21 May 2020

Our Ref: P-18007 (TC)

**RE: RESPONSE TO SYDNEY NORTH PLANNING PANEL DEFERRAL OF DA0134/18
PPS-2018SNH040
ADDRESS: ROSEVILLE MEMORIAL CLUB
PART 62, 64-66 PACIFIC HIGHWAY, ROSEVILLE**

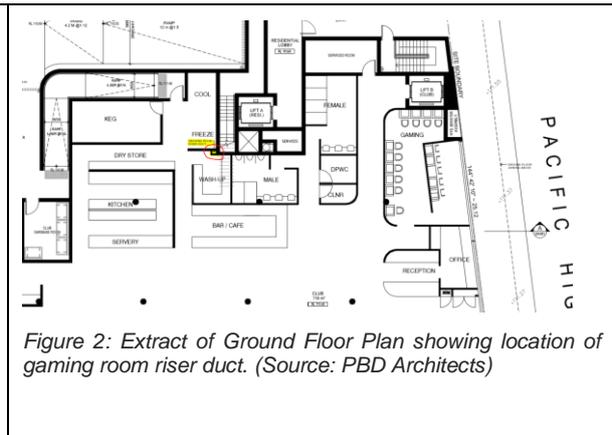
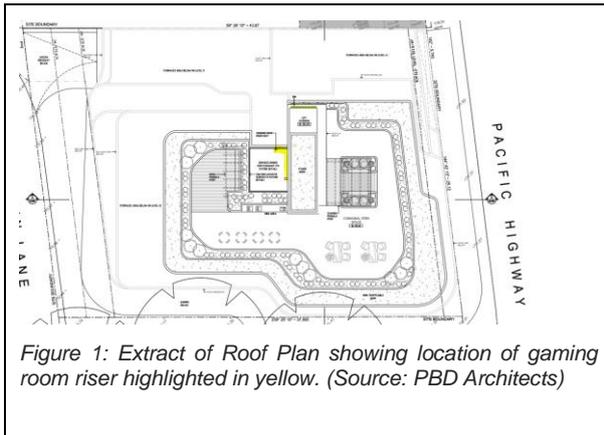
- a) Clarify Car Parking Credits (obtained by the historic monetary contributions paid to Council) and reconsideration of the allocation of spaces between residential and Club with a view to increasing the number of car spaces for the Club staff and patrons.*
- b) Further clarify gaming room smoke exhaust and outlet design and the visual interface between the street and gaming room*
- c) Provide details of sustainability initiatives for the proposed development.*

A new riser duct has been provided from the smoking room, discharging in the centre of the roof, within the services vent area. The location of the riser duct is shown on the floor plans 103 - 108 Revision E and 109 Revision E; also North Elevation DA204 Revision E in the architectural plans for full details. An extract of the ground and roof plans are provided below.

The plans demonstrate that the smoke will be directed away from the street and pedestrians along Pacific Highway. It will be directed out above the centre of the roof and will be situated behind the acoustic screen. Given the distance from any boundary, the discharge of this smoke will not create any detrimental impacts to the surrounding area and is an improvement on the previous scheme.

Figure 4: Extract of Section A-A DA301 Issue E, showing the amendments to the levels. (Source: PBD Architects)

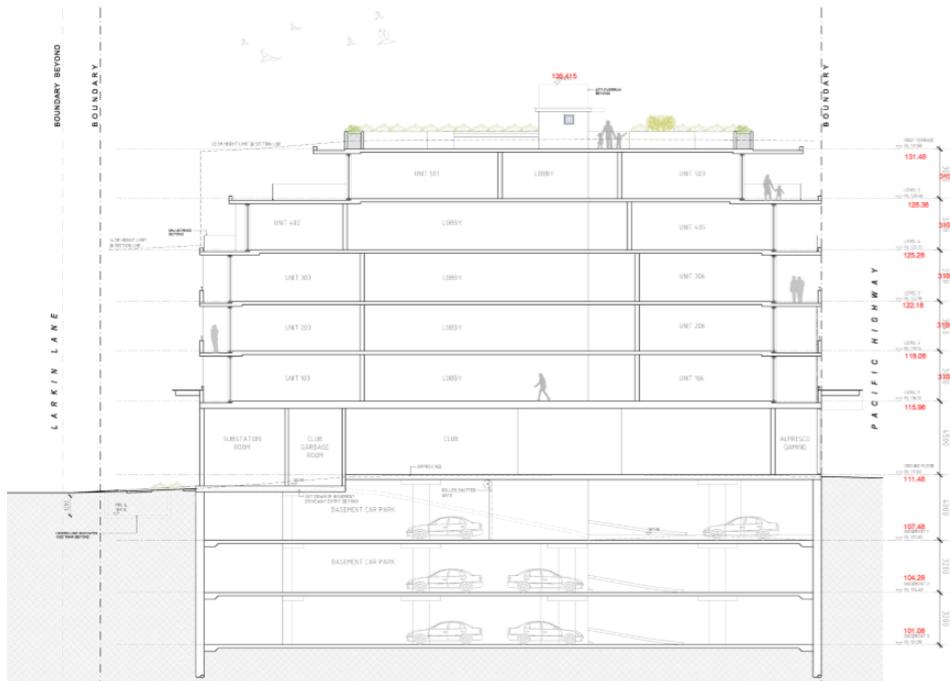
e) Consider redesign to minimise any height breach, given additional uncertainties arising from the likelihood of further shade structures and the constraints of the proposed floor to floor heights.

- The Applicant is requested to consider the resultant impacts from any sprinkler pipes given that they will need to be concealed within the ceiling void - thereby requiring additional head height to ensure the minimum BCA2019 and SEPP 65 head heights are achieved.

The height of the building has been modified in a number of ways to address the issues raised by the Panel and this is demonstrated in diagram DA301 and Figure 4 below. The changes include:

- Basement levels 1-3 inclusive have lowered the RL by 140mm,
- The club internal ground floor level has been lowered by 140mm,

- The floor to floor heights of all residential levels have been altered to be a consistent 3.1m, which is sufficient height to allow adequate services, sprinklers, etc,
- Levels 5 and 6 floors have been lowered,
- A covered pergola has been provided at the Communal Open Space (CoS) level to provide sun and weather protection.

Figure 4 below shows the changes in RLs in red, as compared to the previous scheme.

The amendments achieve a development that provides sufficient head height to allow all required services per floor and is predominantly within the height limit, with the exception of some structures on the roof. The floor level of the CoS is within the height limit as are all habitable rooms associated with the residential units. The only structures that exceed relate to the lift over-run and amenities building providing equitable access to the CoS, the new shade structure, a small portion of the services section and a very minor section of the garden bed balustrading.
